## SOLICITATION AMENDMENT MODIFICATION DE L'INVITATION

<b>Title - Sujet</b> Roof Replacement	
<b>Solicitation No. - N° de l'invitation</b> EP922-171041/A	<b>Amendment No. - N° modif.</b> 002
<b>Client Reference No. - N° de référence du client</b> AAFC EP922-171041	<b>Date</b> 2016-08-25
<b>GETS Reference No. - N° de référence de SEAG</b> PW-\$PWU-201-10829	
<b>File No. - N° de dossier</b> PWU-6-39113 (201)	<b>CCC No./N° CCC - FMS No./N° VME</b>
<b>Solicitation Closes - L'invitation prend fin</b> <b>at - à 02:00 PM</b> <b>on - le 2016-09-02</b>	
<b>Time Zone</b> Fuseau horaire Mountain Daylight Saving Time MDT	
<b>F.O.B. - F.A.B.</b> <b>Plant-Usine:</b> <input type="checkbox"/> <b>Destination:</b> <input type="checkbox"/> <b>Other-Autre:</b> <input type="checkbox"/>	
<b>Address Enquiries to: - Adresser toutes questions à:</b> Ho (RPC), Hector	<b>Buyer Id - Id de l'acheteur</b> pwu201
<b>Telephone No. - N° de téléphone</b> (780) 901-0989 ( )	<b>FAX No. - N° de FAX</b> (780) 497-3510

The following change(s) to the tender documents are effective immediately, and will form part of the contract documents:

2 ) ROOF CONSTRUCTION PLAN  
2.2 1:200

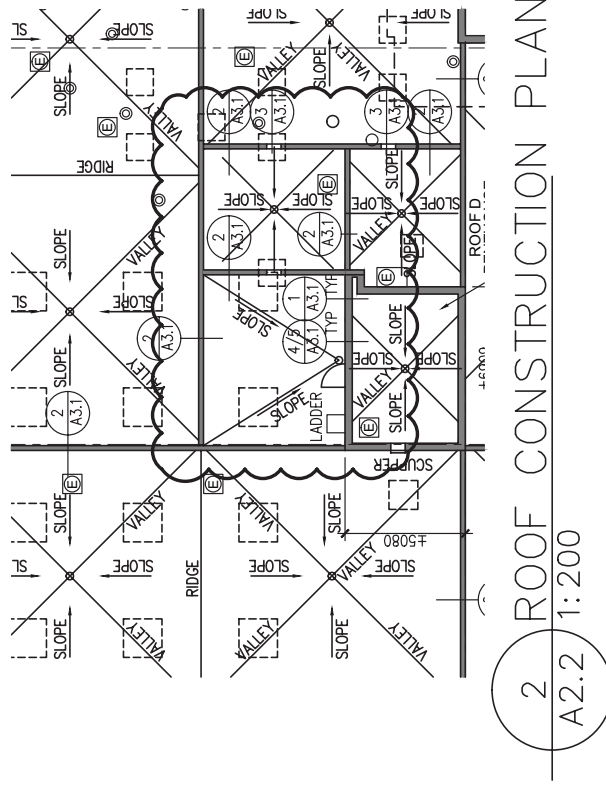
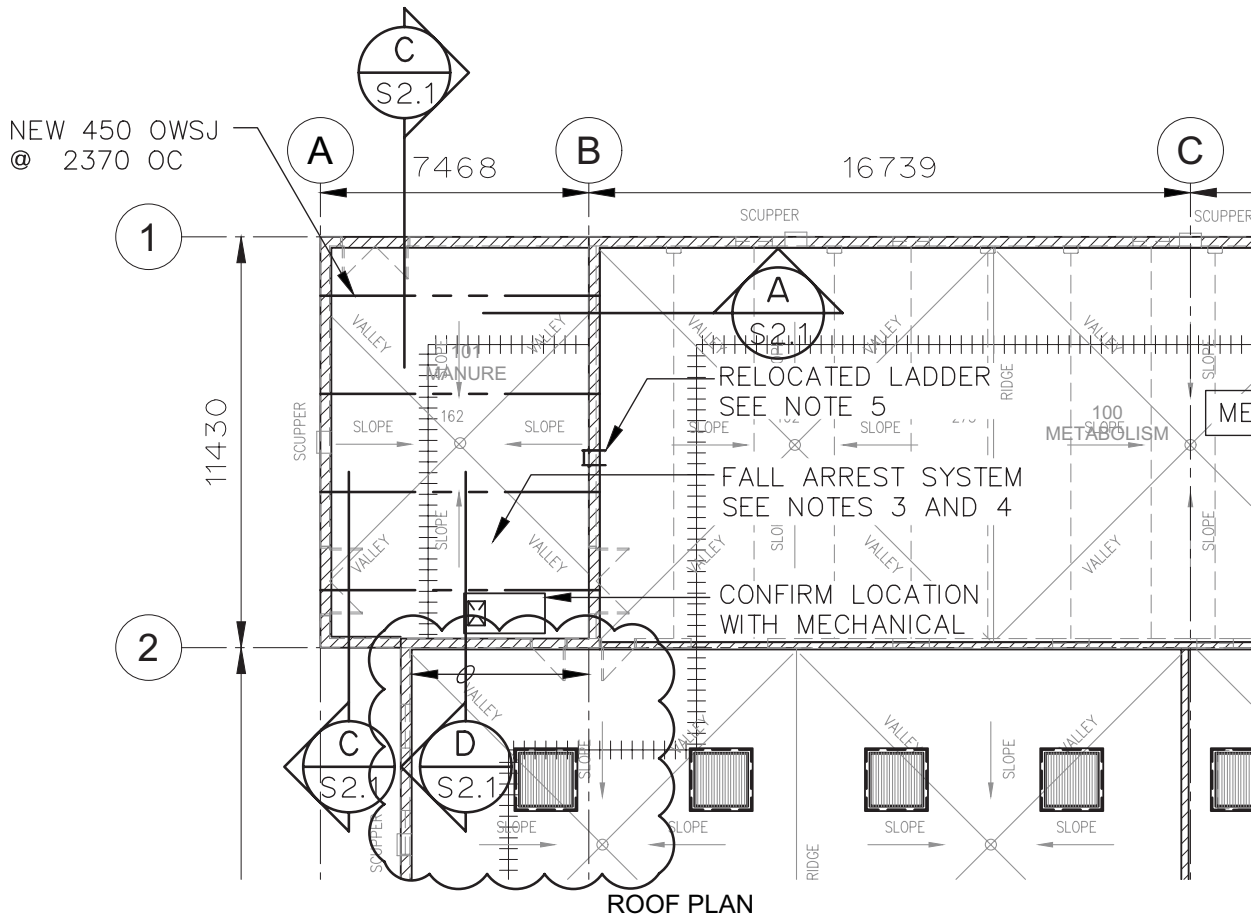
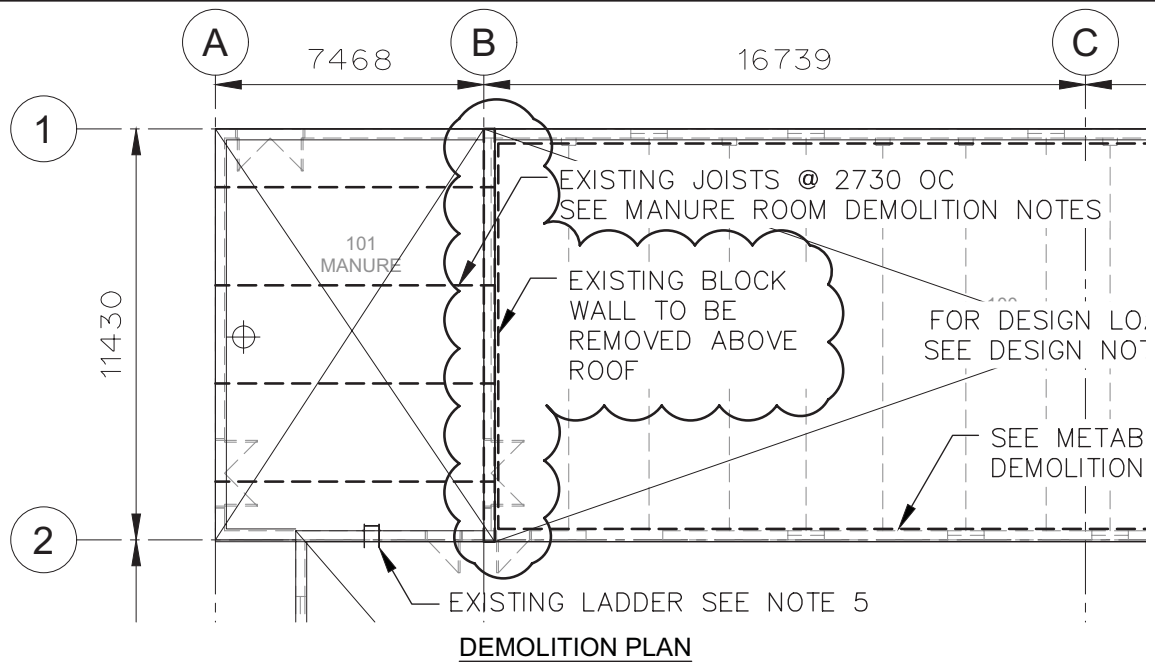
3.1	<p><b><u>Drawing 7/A0.1 – Phasing</u></b></p> <p><b>Add:</b> GENERAL NOTE FOR ALL PHASES: OPERATIONS AND EQUIPMENT IN 101 MANURE AREA IS TO REMAIN IN SERVICE 24 HOURS A DAY, 7 DAYS A WEEK FOR THE DURATION OF THE PROJECT.</p> <p>Refer to attached sketch ASK1.1.</p>
-----	--

3.2	<p><b><u>Drawing 1/A2.1 – RCP Demolition Plan</u></b></p> <p><b>Revise to read:</b> 101 MANURE: REMOVE PRECAST CONCRETE CHANNEL PLANKING AND STEEL ROOF JOISTS. -REMOVE EXISTING CONCRETE BLOCK ON GRIDLINE B AND PREPARE FOR NEW WORK - REFER TO STRUCTURAL. HAZMAT ABATEMENT IS REQUIRED AT THIS LOCATION DUE TO VERMICULITE IN CORES. -CUT OFF ALL EXISTING STRUCTURE FLUSH WITH WALLS, DO NOT REMOVE EMBEDS ON GRIDLINES B AND 2 - WALLS CONTAIN HAZMAT VERMICULITE.</p> <p><b>Add:</b> REMOVE PORTION OF EXISTING SHED ROOF AS REQUIRED, RE-INSTALL.</p> <p>Refer to attached sketch ASK1.1.</p>

3.3	<p><b><u>Drawing 2/A2.2 – Roof Construction Plan</u></b></p> <p>In order to accommodate the door sill and mechanical vent on the north side of the roof penthouse, an additional roof curb, gutter and scupper are required. Slope this area of the roof to the drain; locate drain adjacent to wall.</p> <p>Refer to attached sketch ASK1.1.</p>

DRAWING: SSK1

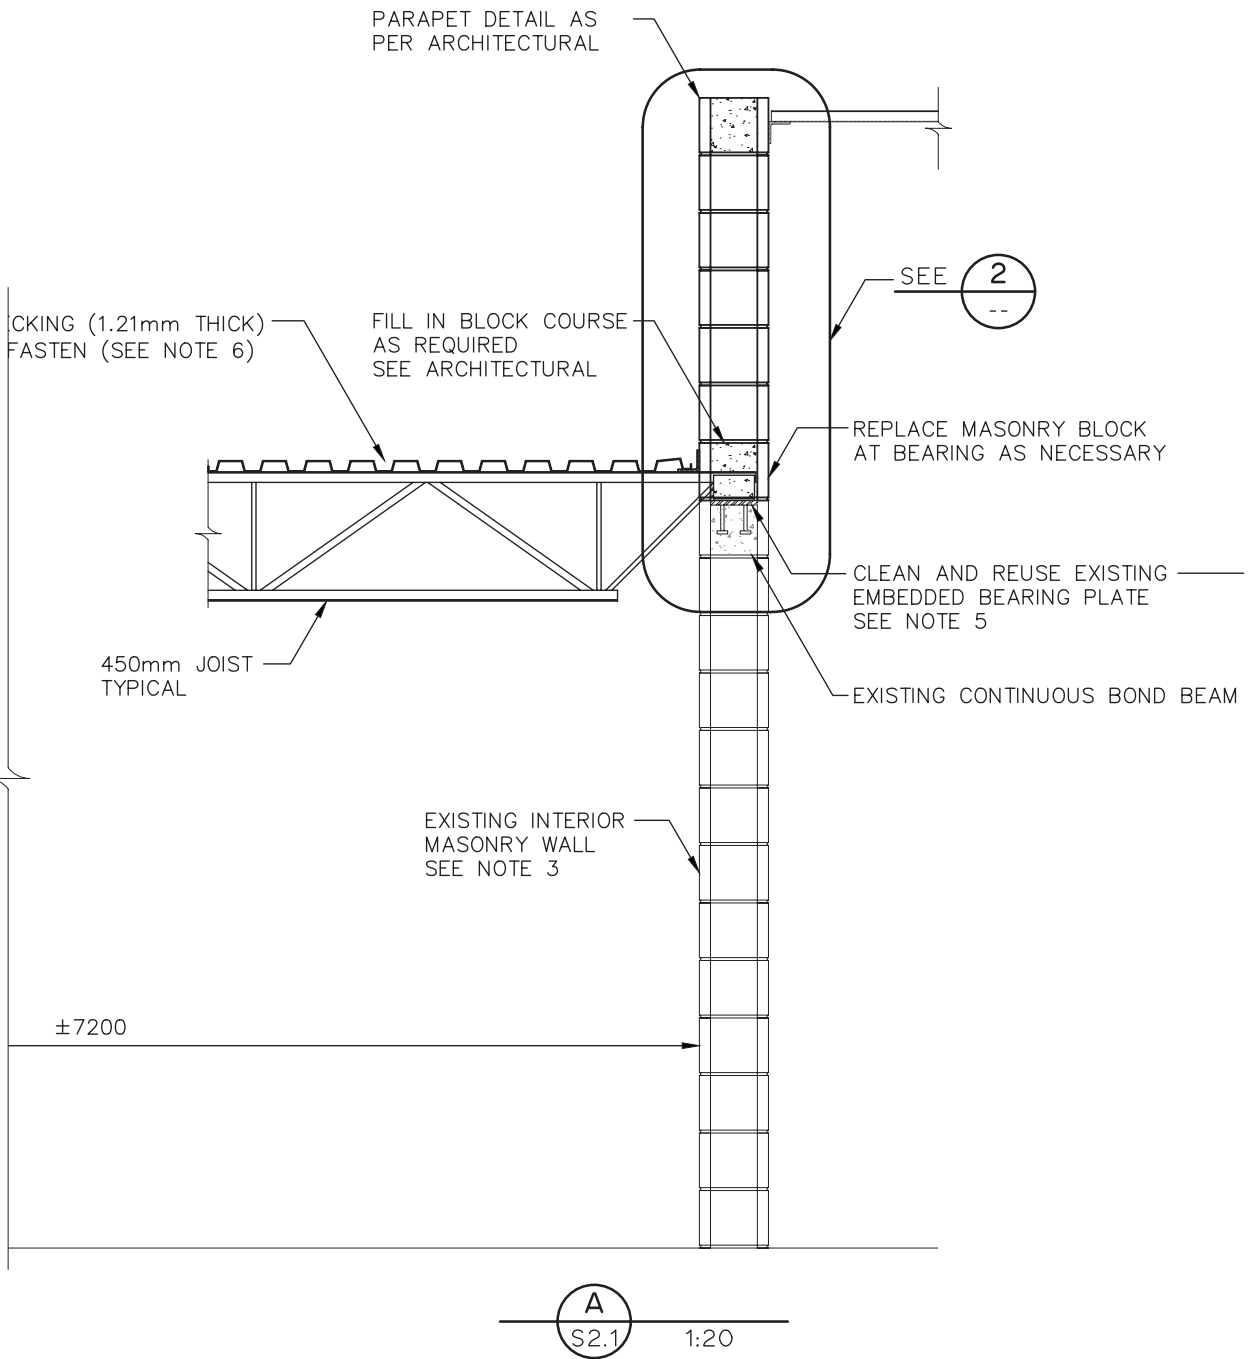
3.4	<p><b><u>Drawing S1.1 – Structural Demolition and Proposed Plans</u></b></p> <p><b>Clarification:</b> All existing steel concrete imbedments that are being removed or relocated are to be cut off from existing walls and ground flush to avoid removal that may disrupt existing walls containing asbestos that are not identified for abatement.</p> <p><b>Clarification:</b> Remove and replace 7 rows of masonry, between gridlines 1 and 2, along grid line B. Coordinate removal with asbestos abatement. See attached Structural Detail on SSK001.</p> <p><b>Add:</b> Support for Q-decking along grid line 2 to be provided by existing support angle bolted to adjoining wall, and existing deck ledge on exterior wall. Coordinate for installation of additional tubing or angles to match Q-deck height, and painting of re-used structural material. New ledger angles not to be anchored into walls containing asbestos.</p>

3.5	<p><b><u>Drawing S2.1 – Structural Details</u></b></p> <p><b>Add:</b> See section details for proposed structural work on Structural Detail on SSK001, SSK002, and SSK003.</p>
